Rezoning Transportation Analysis

Petition Number: #2022-161

Date	Description
02-23-23	First Review (PDM)

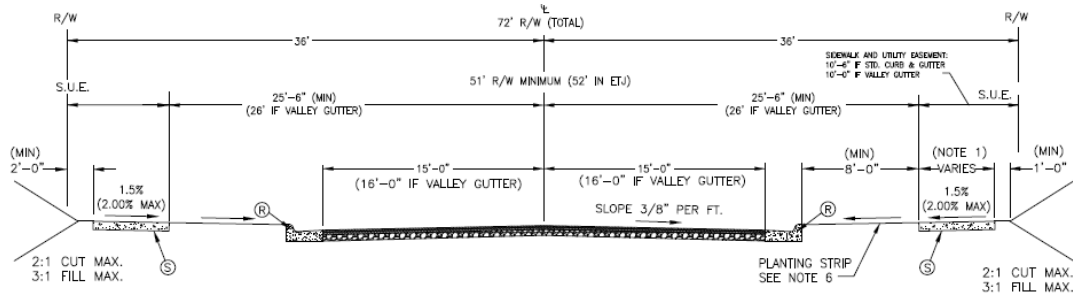
- a. **Steele Creek Road:** Location of the future curb and gutter to be installed at 33 feet from roadway centerline to accommodate the Charlotte Streets Map roadway typical section of four plus lane avenue with shared use path. The future curb and gutter should be shown on the plan and dimensioned from the centerline.

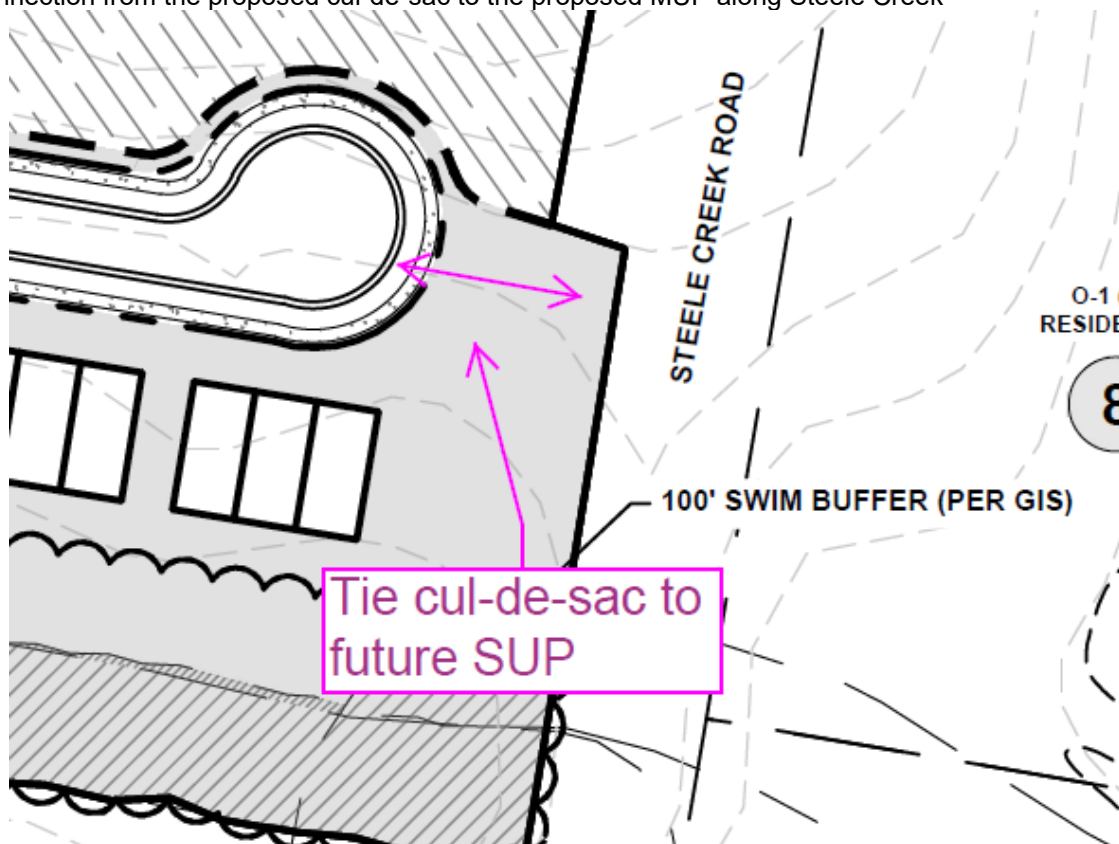
- b. **Parkside Crossing:** Location of the future curb and gutter to be installed at 17.5 feet from roadway centerline to accommodate the Charlotte Streets Map roadway typical section of collector street per CLDSM U-07. The future curb and gutter should be shown on the plan and dimensioned from the centerline.

Label and dimension the curb and gutter from the centerline for each road on the site plan.

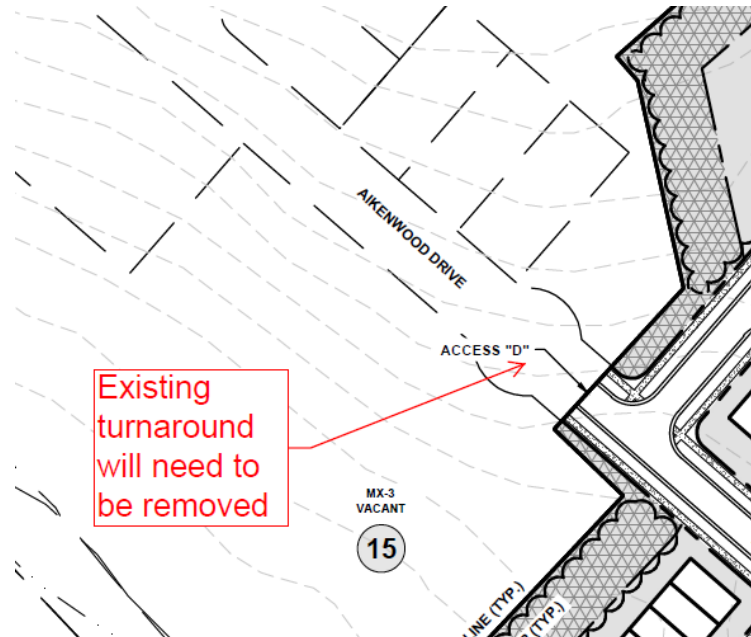
7. Revise site plan and conditional notes to commit to removing the existing turnaround on Aikenwood Drive at the proposed Access D Street connection.
